ADDENDUM NO. 1

Addition and Renovation
PTECH INNOVATION CENTER
700 N. Union Street
Winchester, IN 47394

PROJECT 2275-1

drawing
S1-A

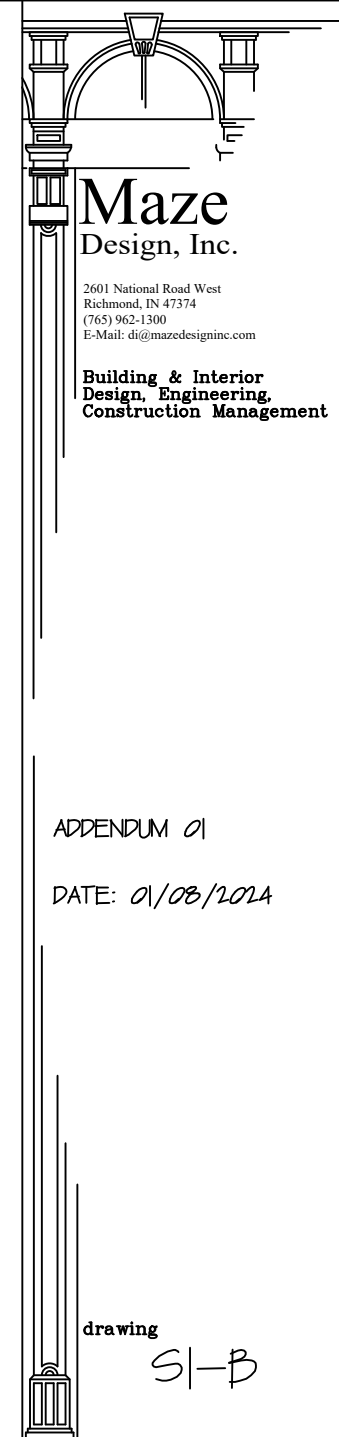
- Drawing S1, SD1: see revised sketch S1-A, S1-B, SD1-A. Sketches show 6" cmu wall, reinforcement and thicken slab for wall between breakout are 106 and 107.
- Drawing a1.1 see revised sketch A1.1-A. Sketch shows the add alternate #1 bid for the canopy.
- Drawing a6.1 see revised sketch A6.1-A. Sketch shows revised aluminum frame detail 3.

SI-B

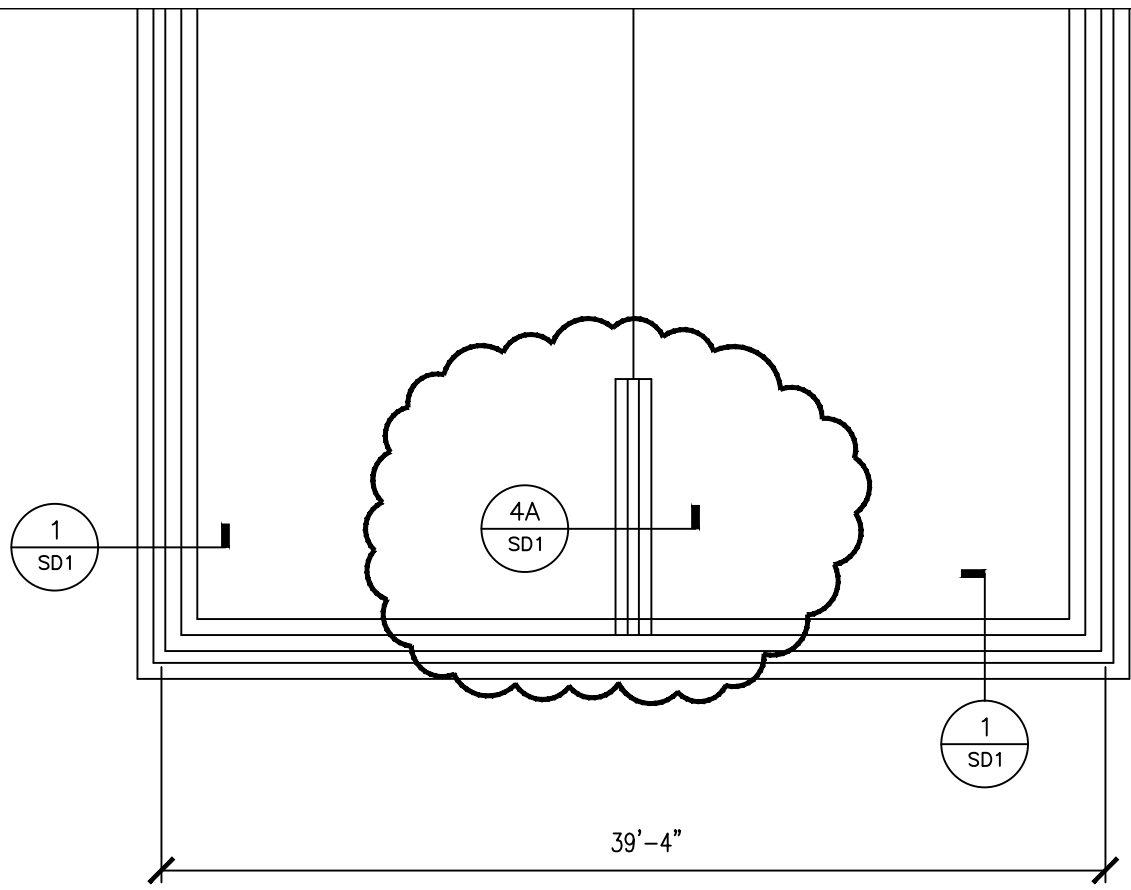
#5 BARS @ 48" O.C.
SEE MASONRY PLAN FOR
ADDITIONAL REINFORCEMENT

#5's @ 48" O.C.
DOWEL AND EPOXY
A MINIMUM OF 6"

drawing
SD1-A

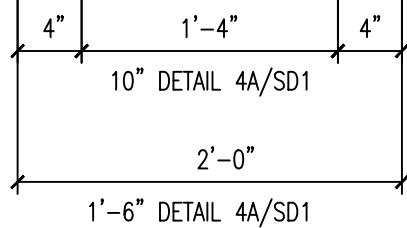
4" CONCRETE SLAB WITH
6 x 6 W1.4 x W1.4
WELDED WIRE FABRIC
(4,000 PSI CONC.)

BOTTOM OF THICKENED
SLAB ELEV. 99'-4"

(2) #5'S CONTINUOUS

drawing
A.1-A

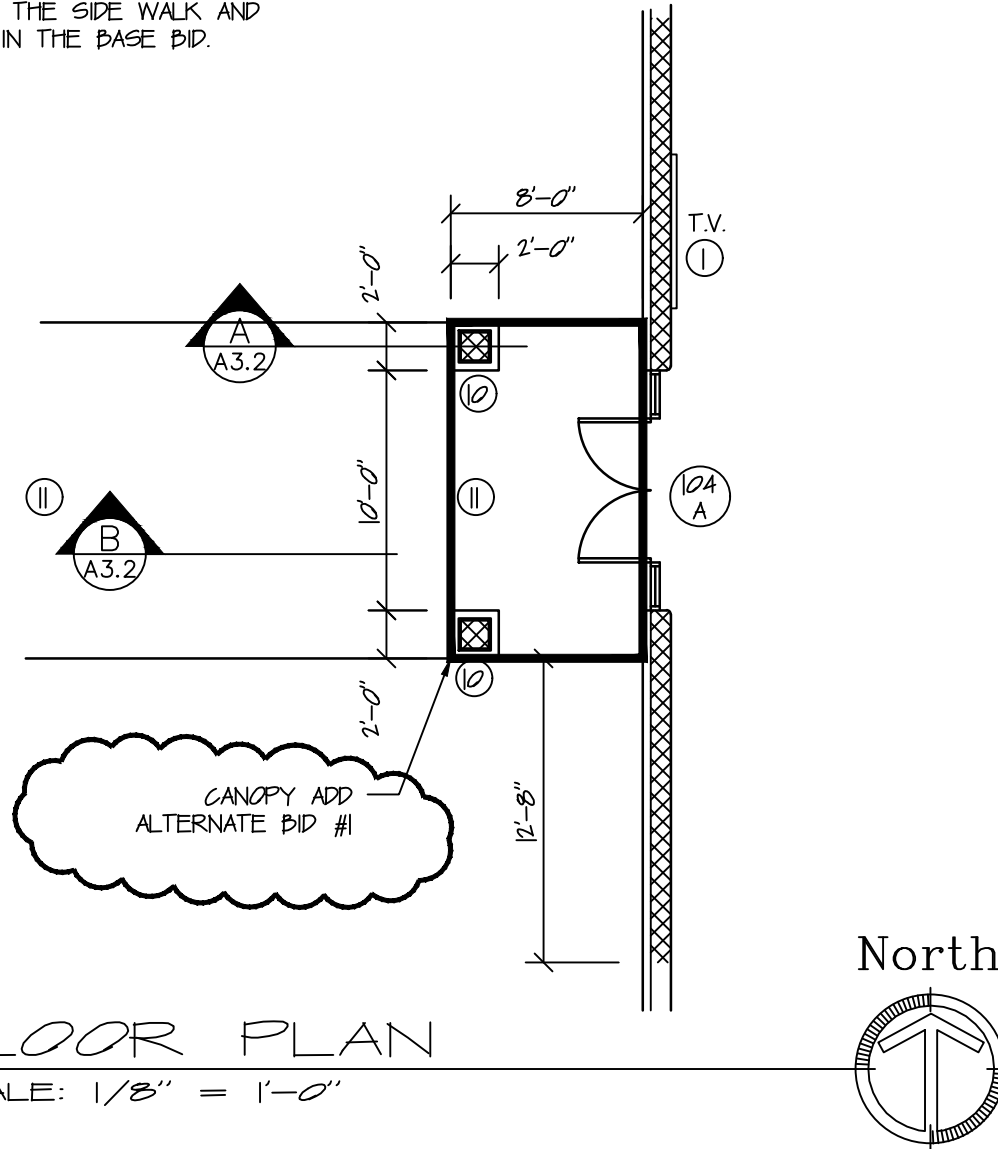
ALL WORK FOR THE 8'x14' CANOPY SHOWN ON THIS SKETCH SHALL BE ADD ALTERNATE BID #1 AS LISTED ON THE BID FORM. NOTE THE SIDE WALK AND TRENCH DRAIN SHALL BE IN THE BASE BID.

A6.1-A

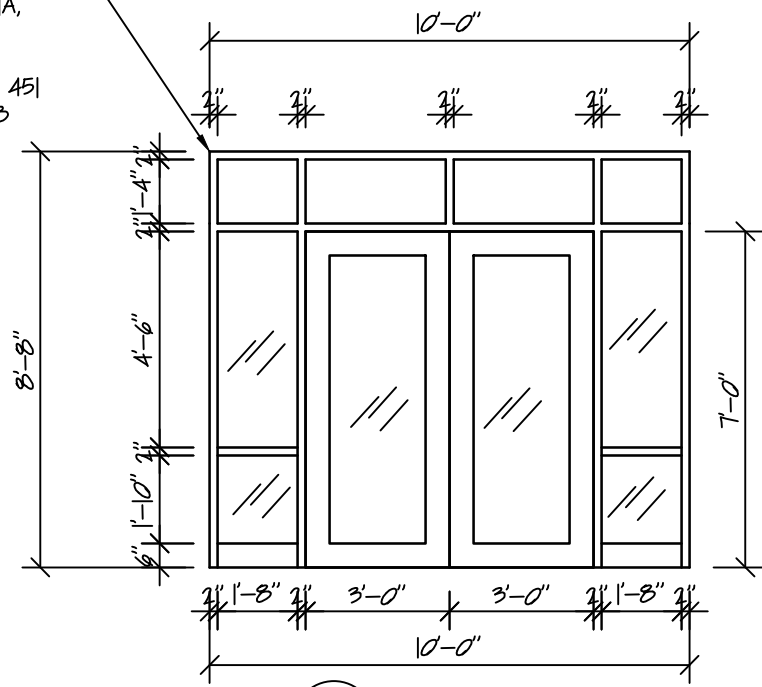
KAWNEER 451T
DOORS 101A,
104A, 105A

KAWNEER 451
DOOR 104B
